M.S.A.H. 125 (ARCADE STREET)
RAMSEY COUNTY
MAPLEWOOD/LITTLE CANADA, MN

ASBUILT PLAN
CONFORMING TO
CONST. RECORDS

TITLE: PRECAST CONCRETE
ARCH STRUCTURE
EXCAVATION & BACKFILL

TITLE: AS-BUILT BRIDGE DATA	DES: CHK:	DR: CHK:	APPROVED:	BRIDGE NO. 62570
	SHEET NO. B21 OF 21 SHEETS

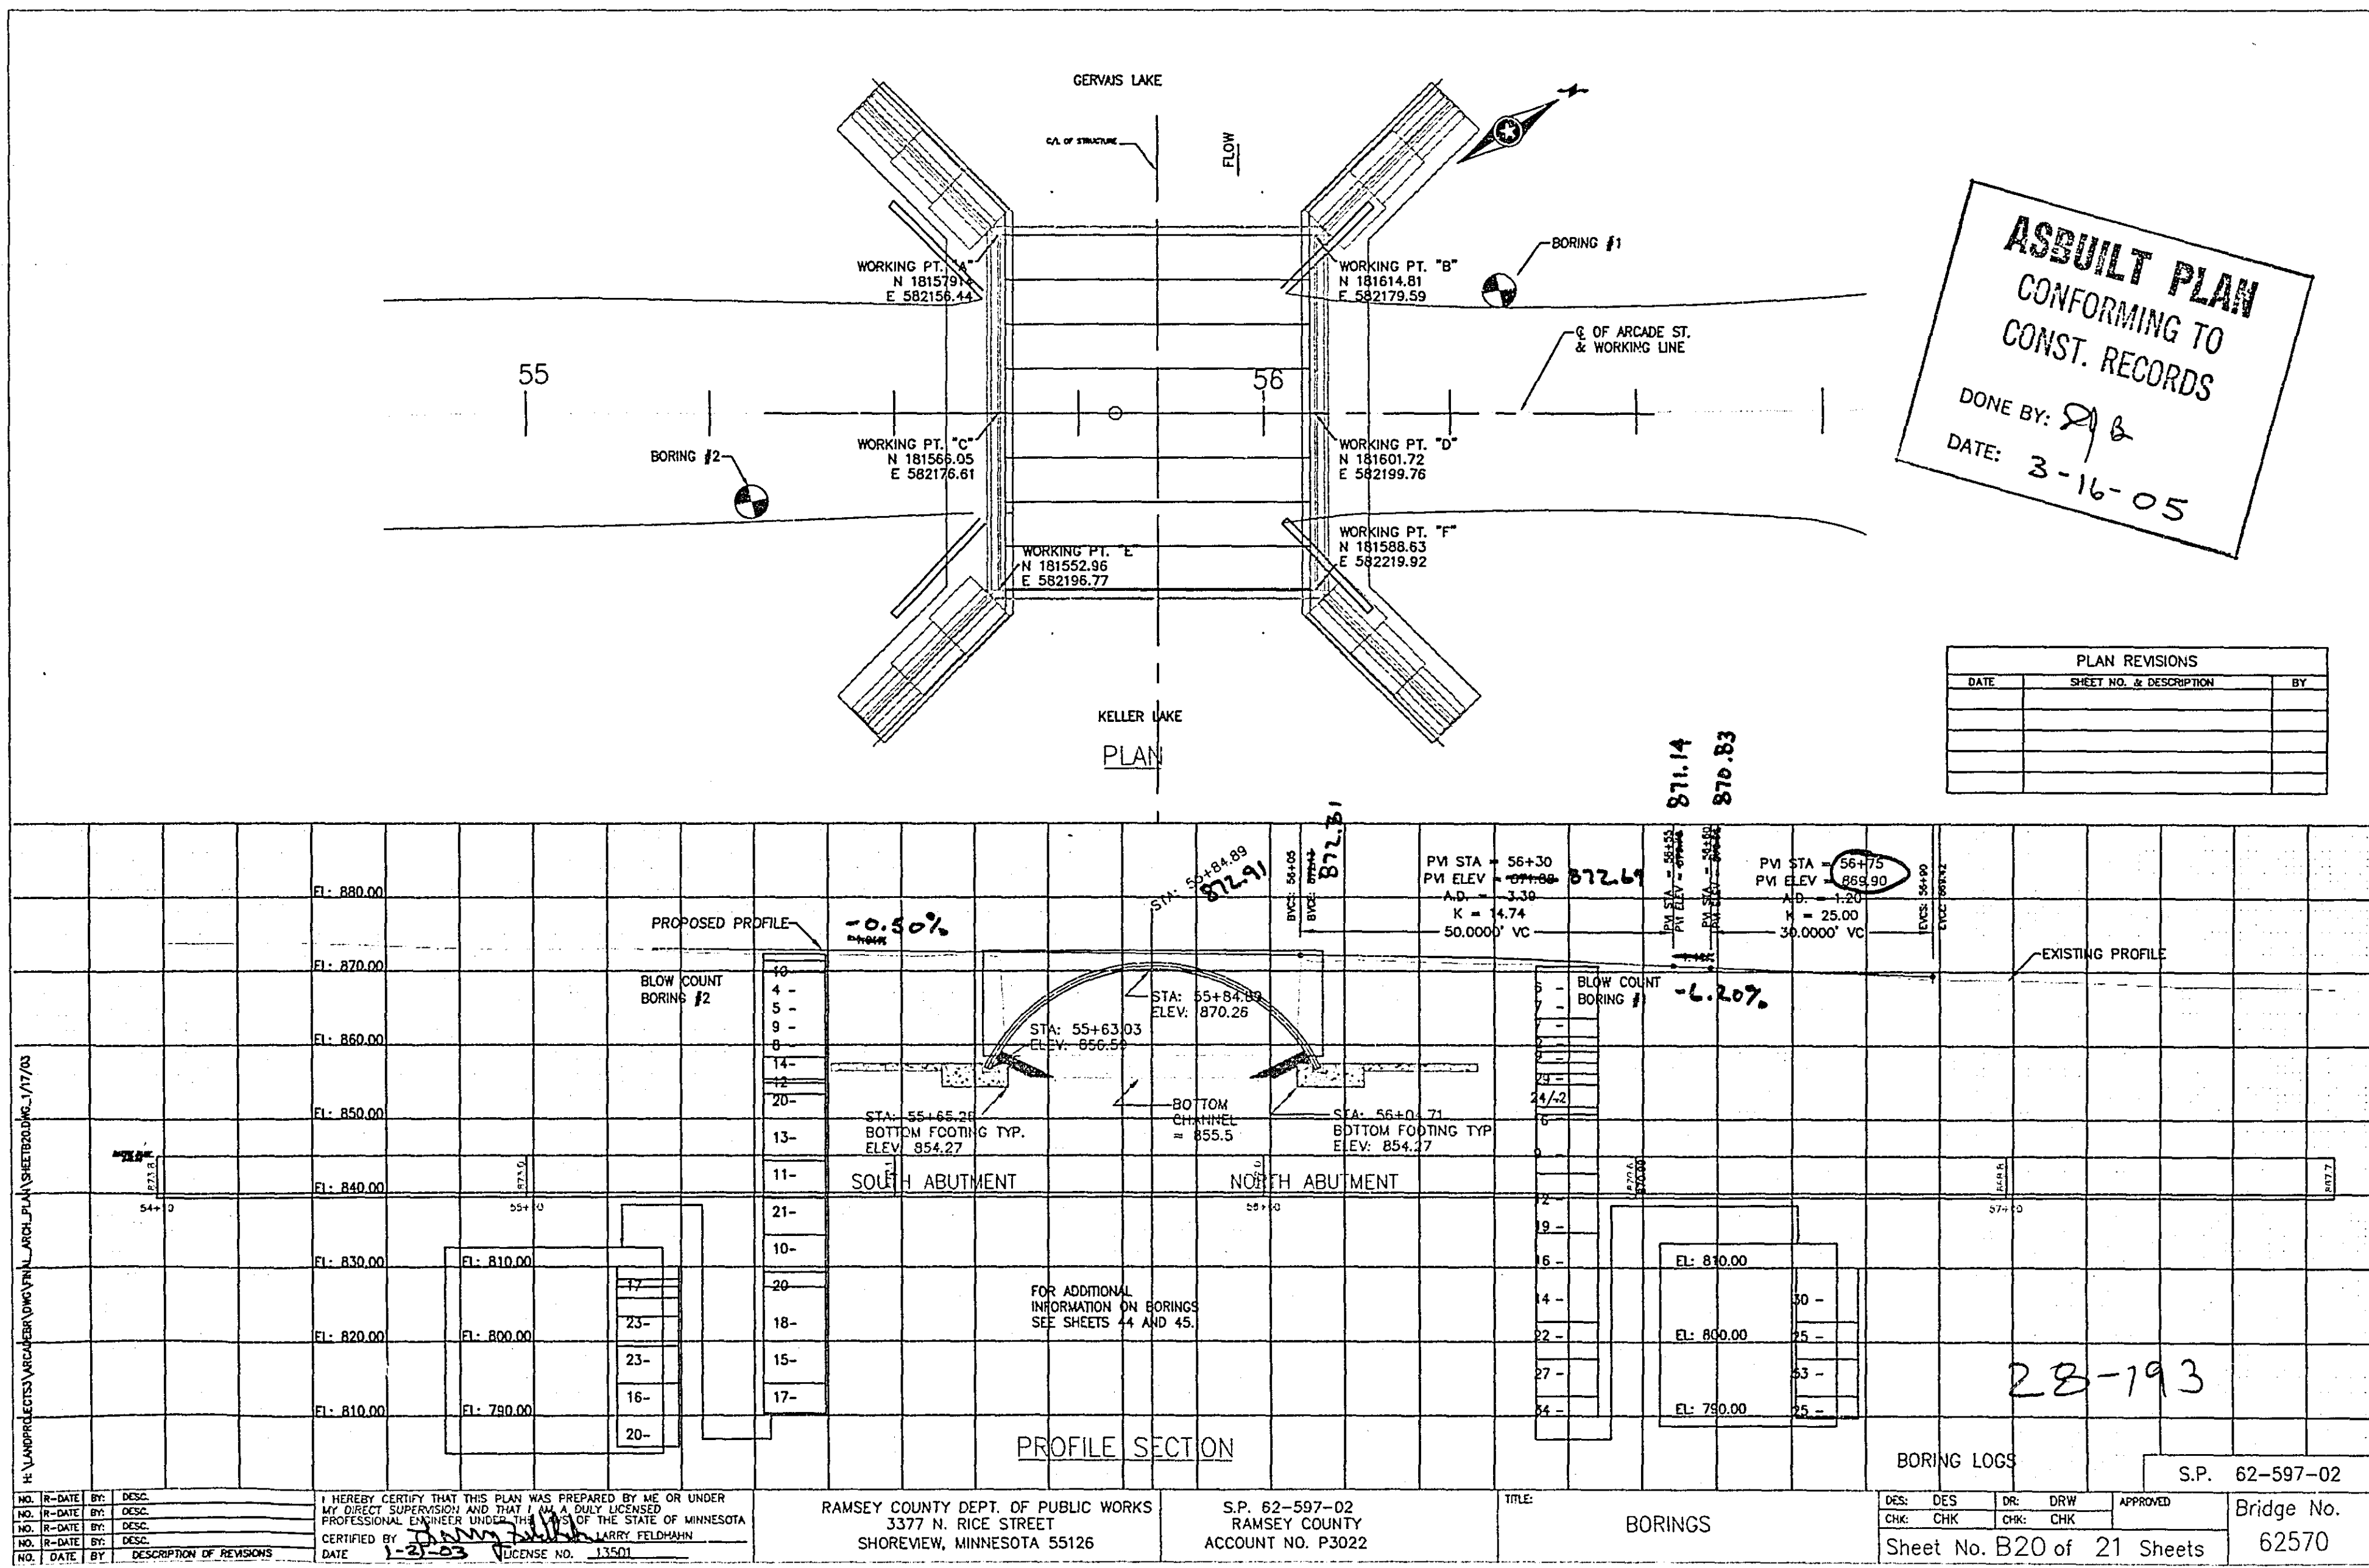
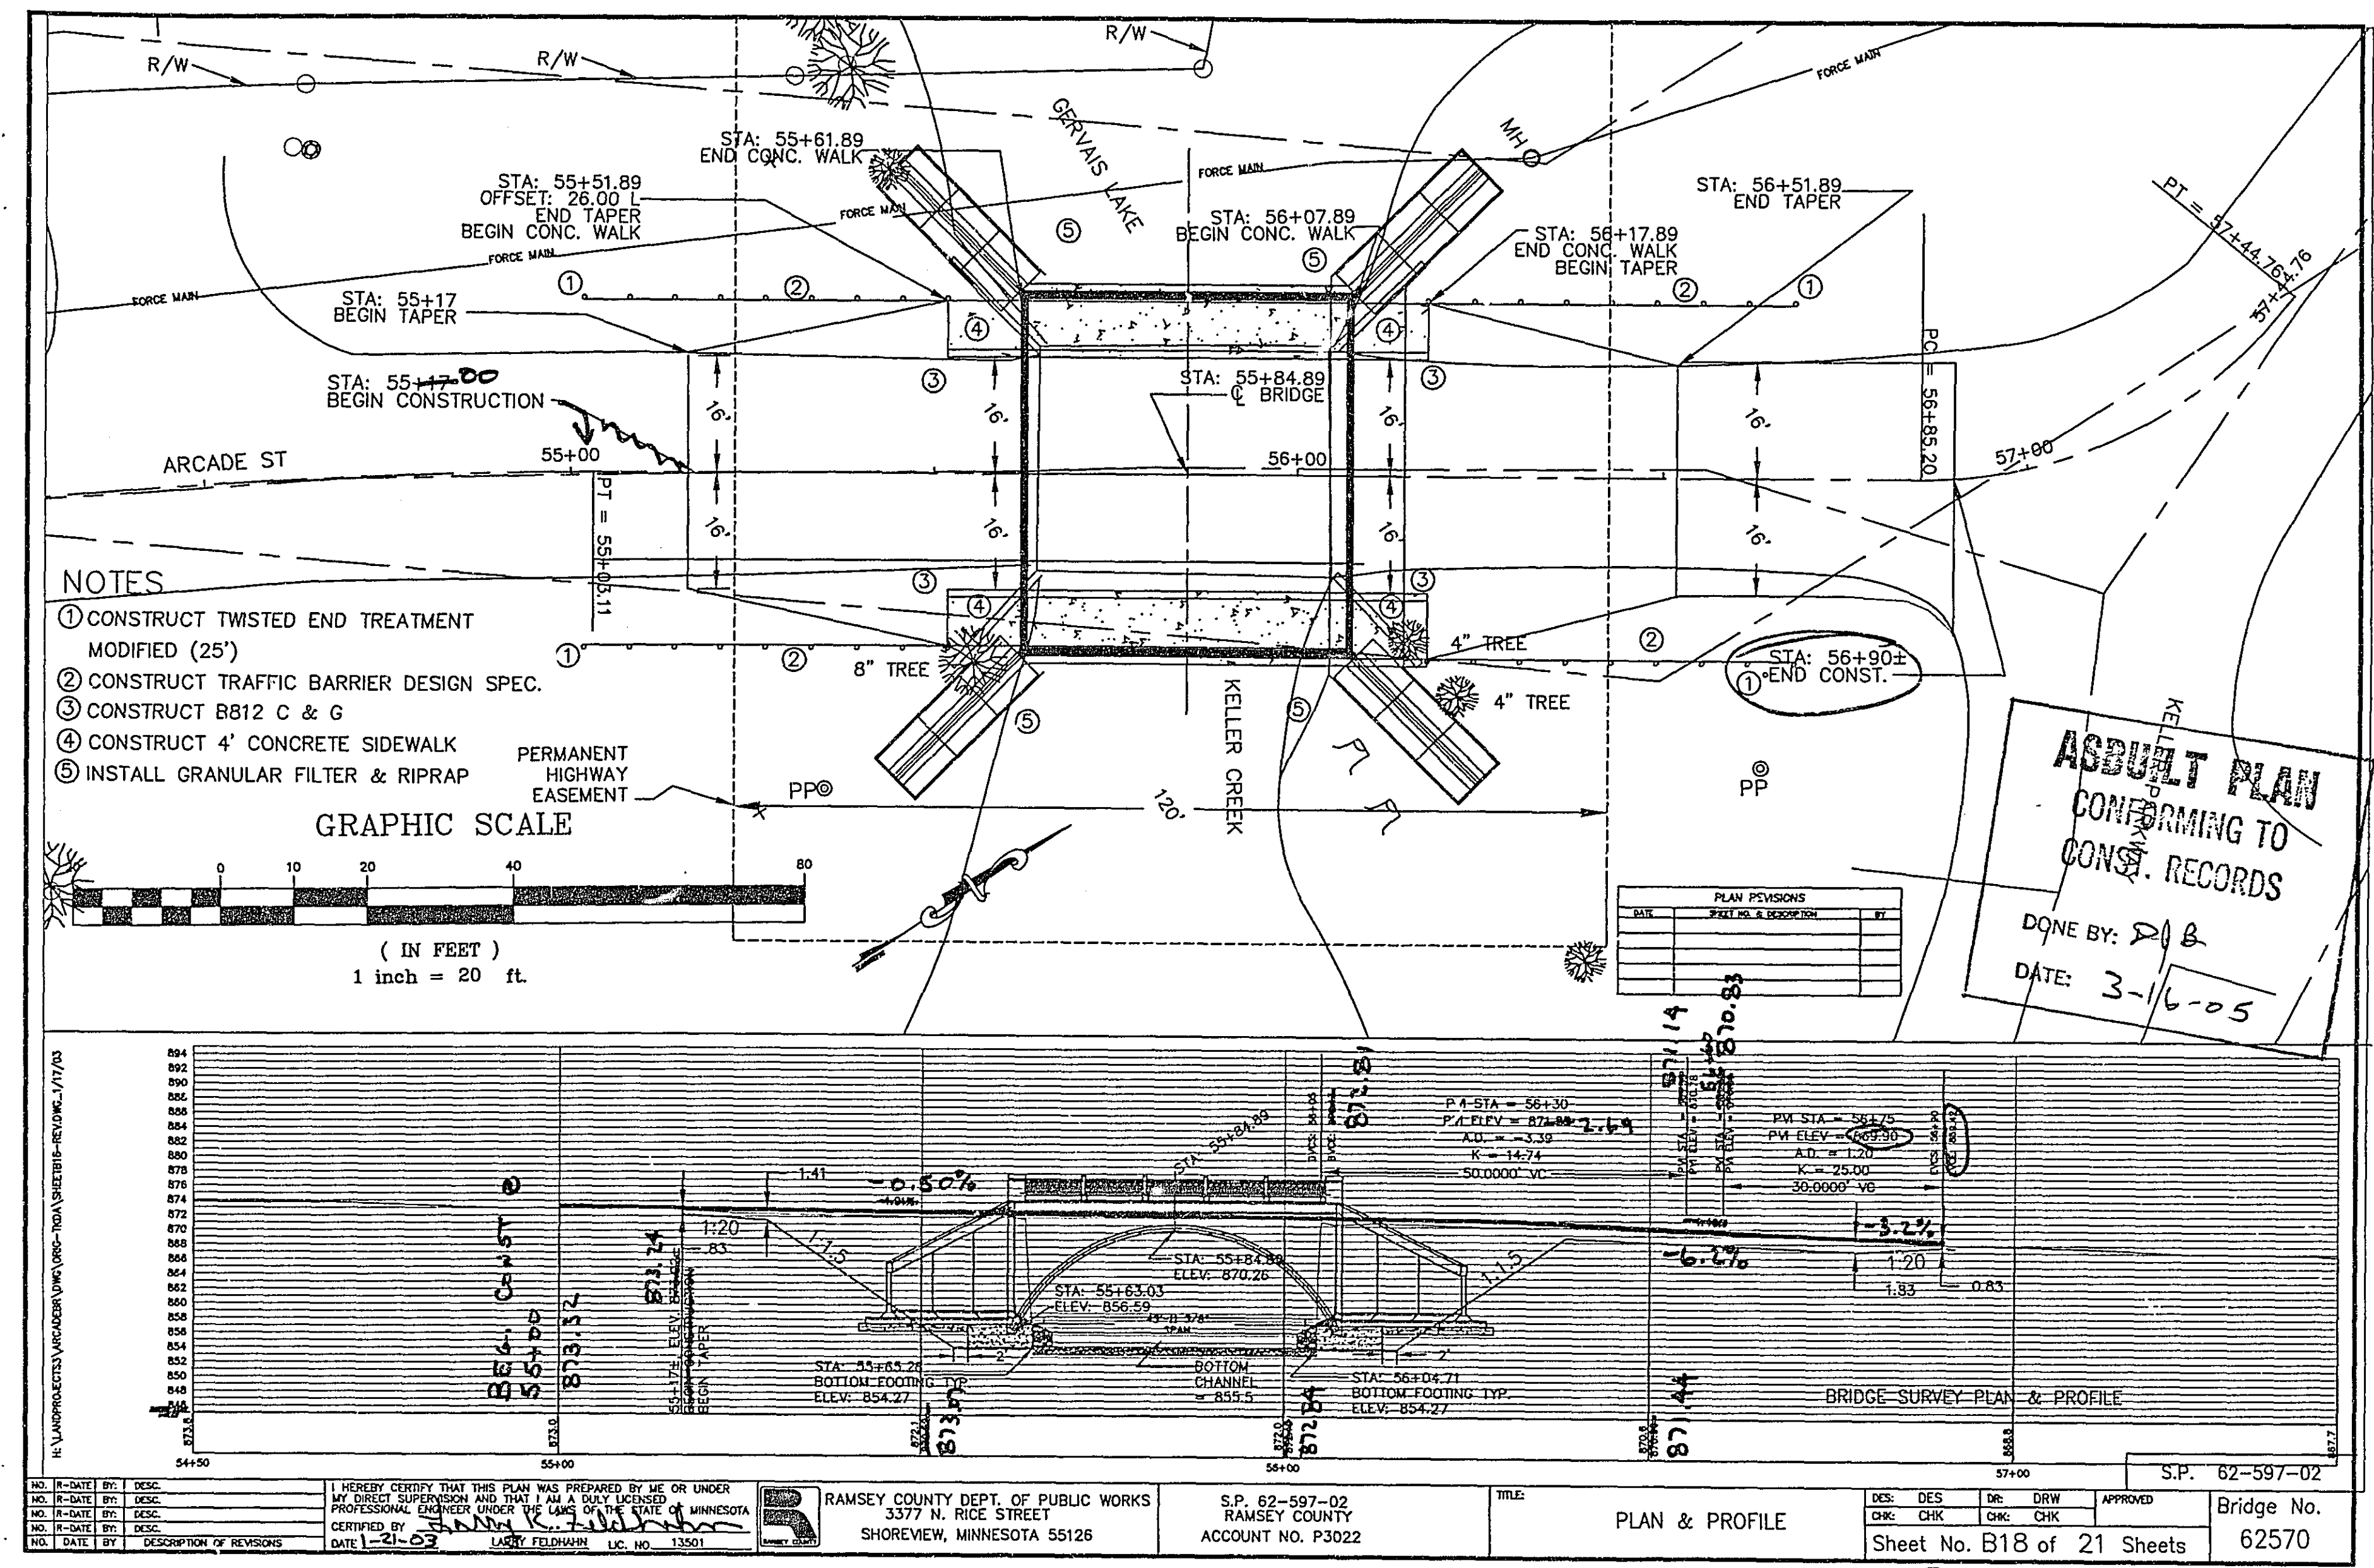
SUMMARY OF SIGNIFICANT AS-BUILT CHANGES

RAISED PROFILE GRADE OVER BRIDGE
